ELEVATION - NORTH BRIDGE RAIL FACING NORTH FROM CL OF ROADWAY

ITEM 525.43 STEEL BRIDGE RAIL - HDSB W/HANDRAIL  
 TOWN OF BRATTLEBORO, WINDHAM COUNTY  
 TH 378 (WILLIAMS ST.) OVER WHESTONE BROOK  
 BRIDGE No. 34  
 PROJECT No. BHF 2000(22)

ACCEPTED AS CORRECTED ✓  
 REJECTED, REVISE AND RESUBMIT  
 REJECTED, UNACCEPTABLE

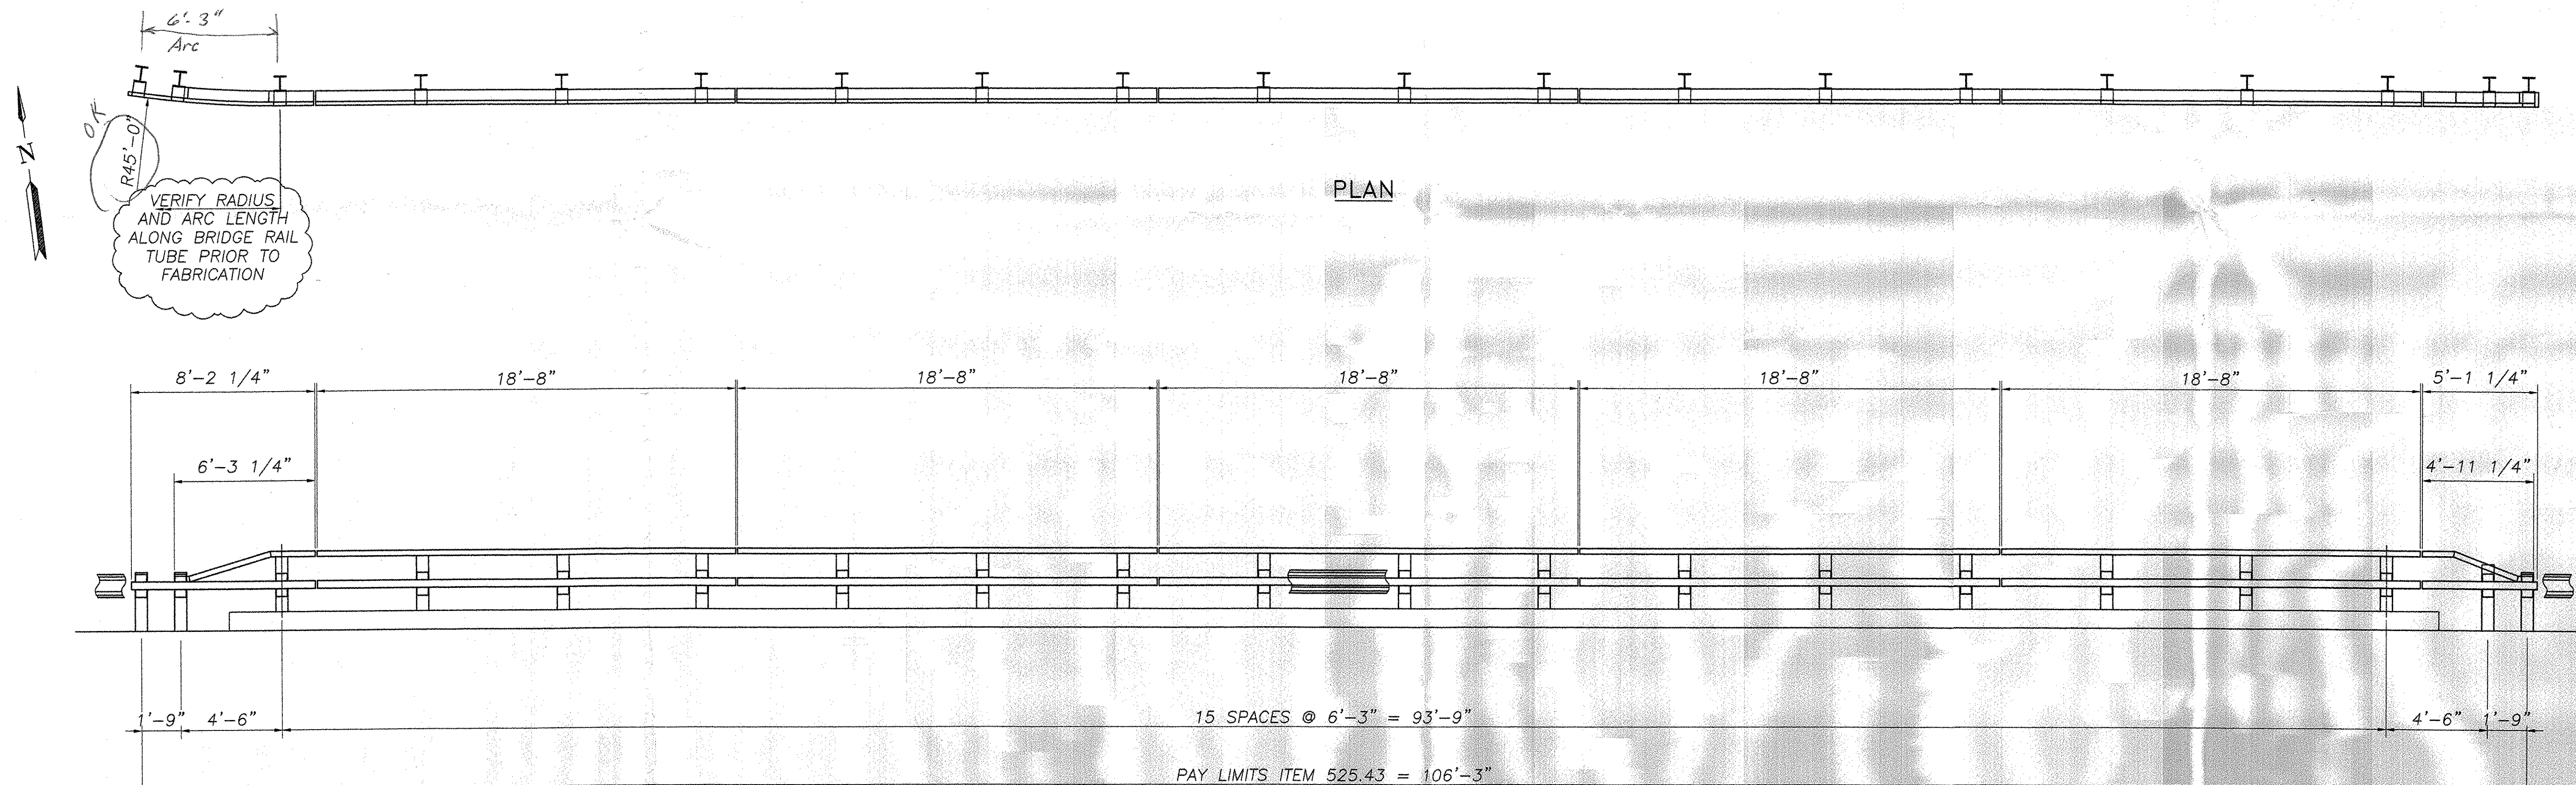
*The Bill of Materials was not checked by the reviewer*
